Site Investigation Work Plan Addendum, Madison-Kipp Corporation, 201 Waubesa Street, Madison, Wisconsin. Facility ID No. 113125320, BRRTS No. 02-13-001569

Investigation Work Plan Addendum

MADISON-KIPP CORPORATION
 201 WAUBESA STREET
 MADISON, WISCONSIN

PROPOSED WELL LOCATIONS

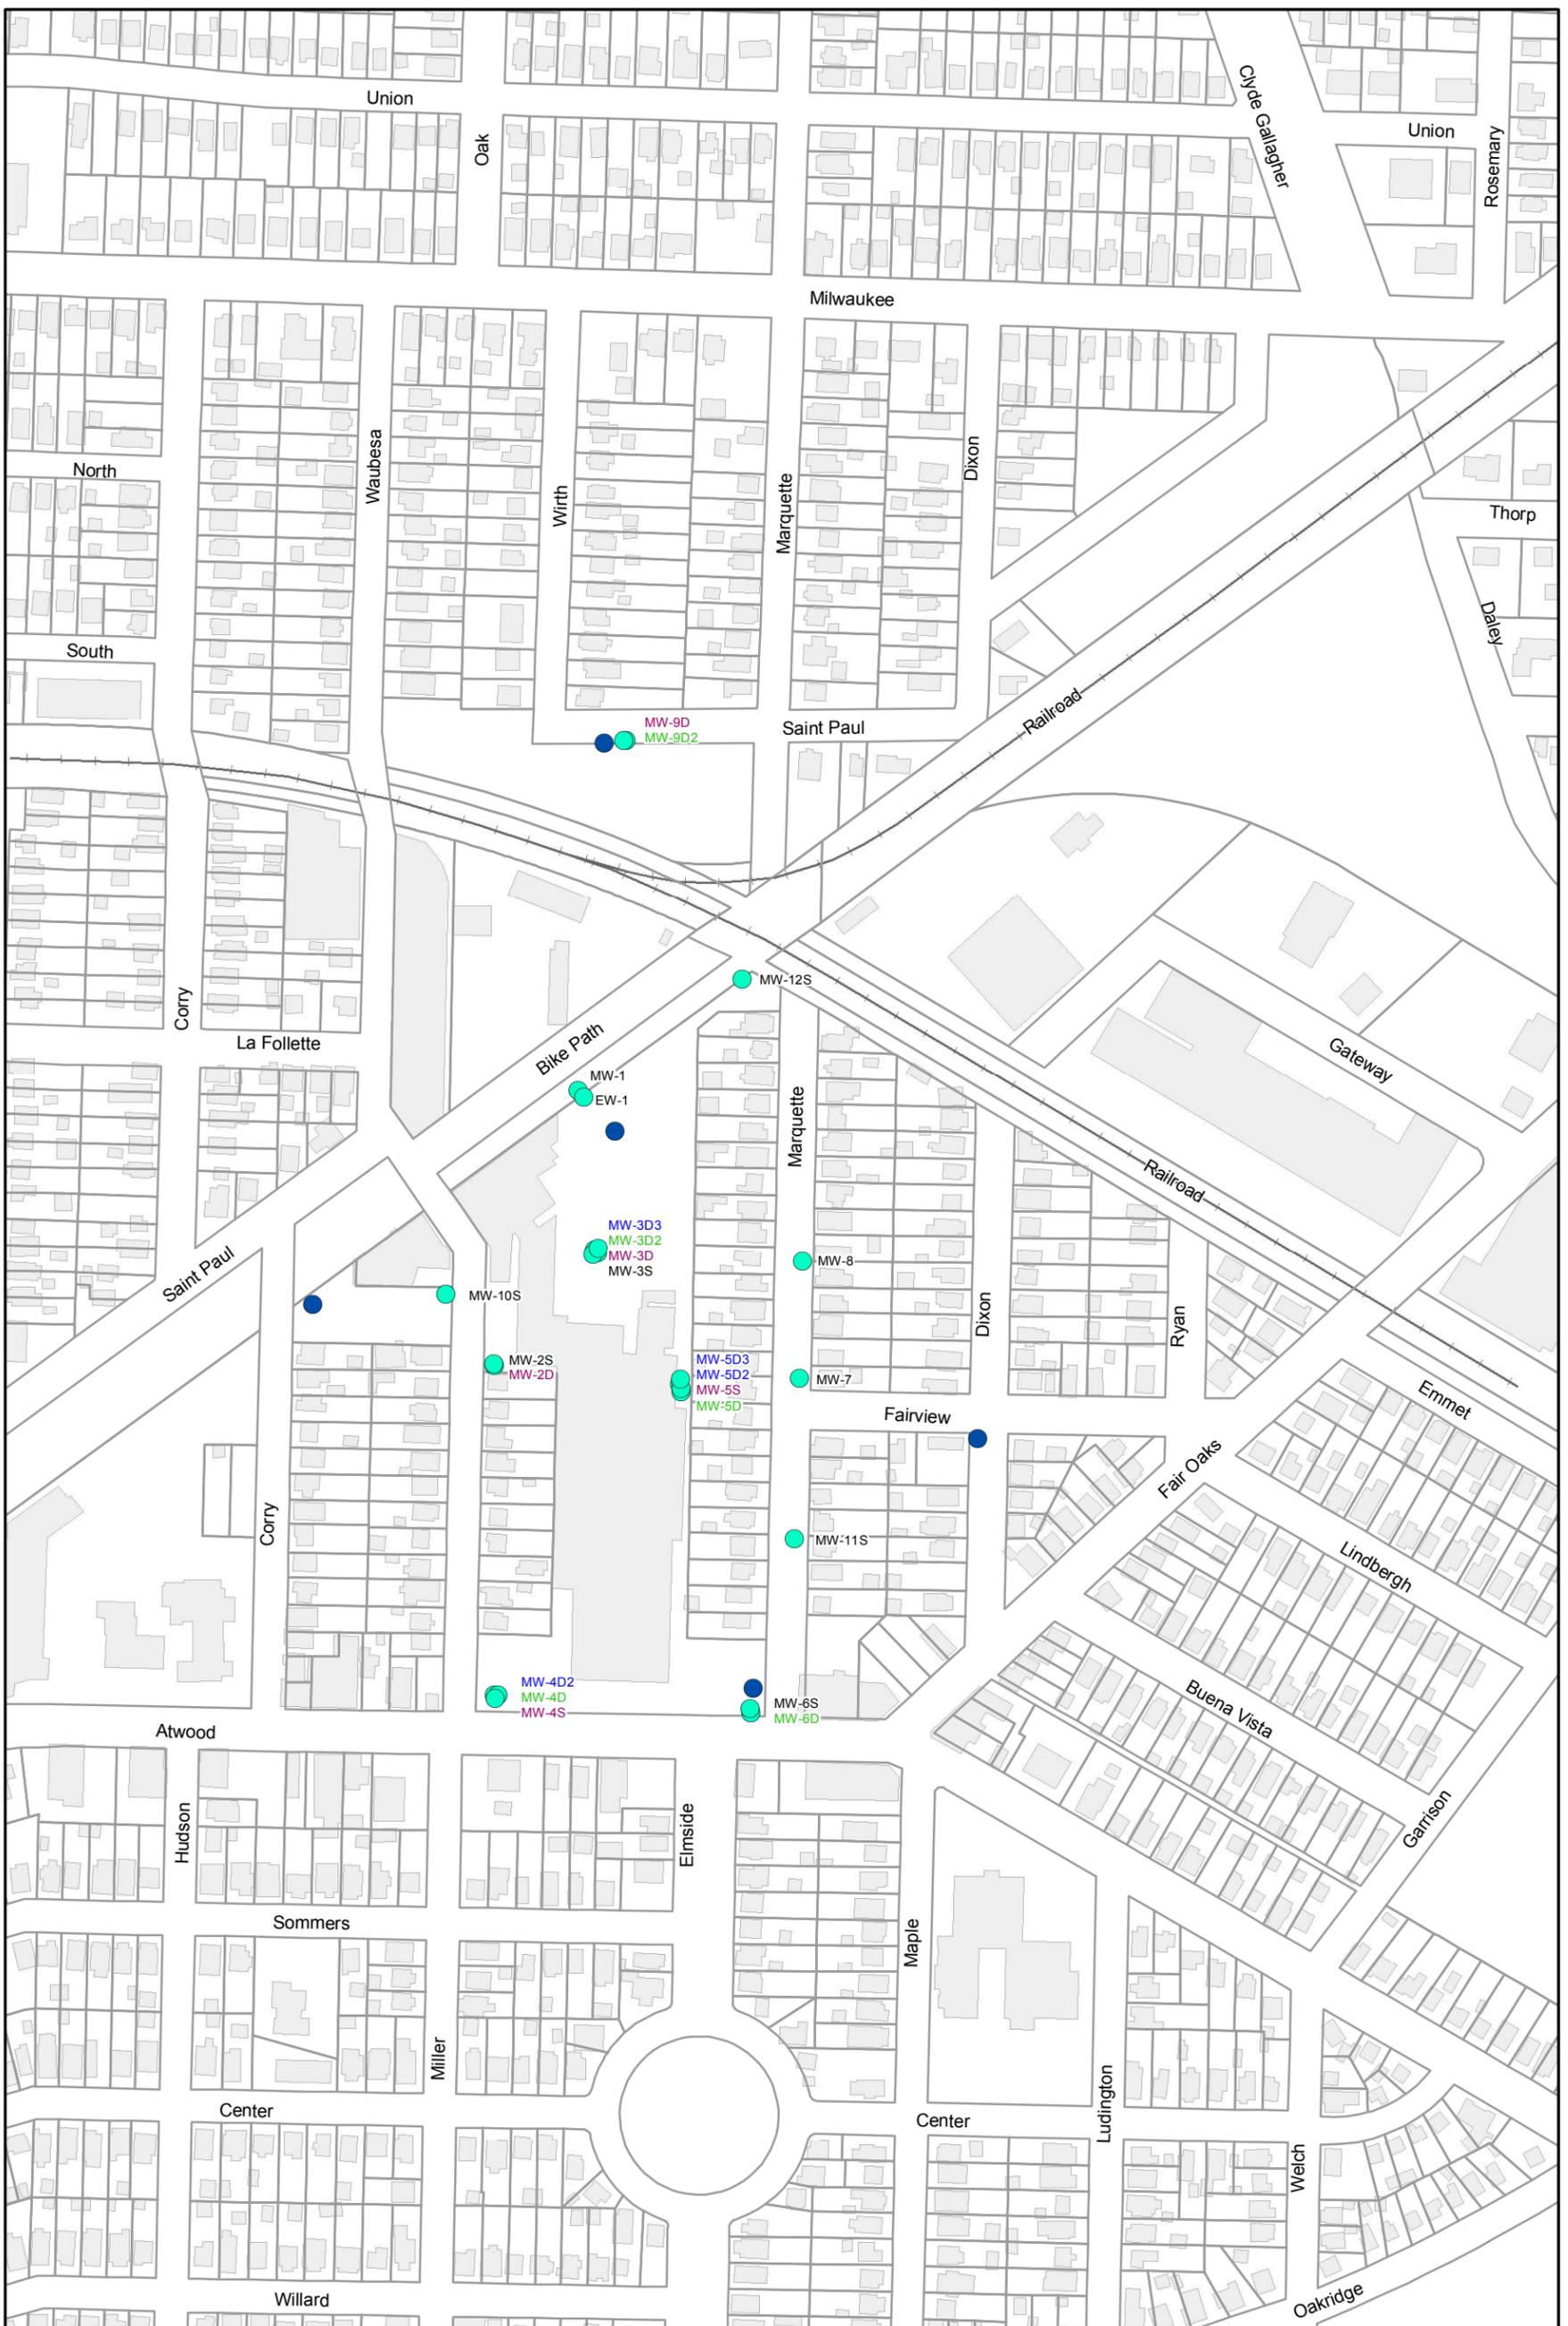
Five additional wells will be installed to further evaluate the horizontal and vertical extents of groundwater impacts on-site and off-site (Figure 1). The following is an overview of locations that were agreed to at the August 23 meeting.

- One well will be located at the west entrance to the Madison-Kipp parking lot located on the west side of Waubesa Street.

- One well will be located in the Madison-Kipp north parking lot between Monitoring Well MW-1 and the Monitoring Well MW-3 well nest.
- One well will be nested with the Monitoring Well MW-6S/D well nest located in the Madison-Kipp southeast parking lot.
- One well will be located at the intersection of Fairview Street and Dixon Street.
- One well will be nested with the Monitoring Well MW9D/D2 well nest located in the right-of-way of Saint Paul Avenue.

It should be noted that the proposed well locations depicted on Figure 1 are approximate and may need to be modified in the field based on impediments such as underground and aboveground utilities and parkway vegetation.
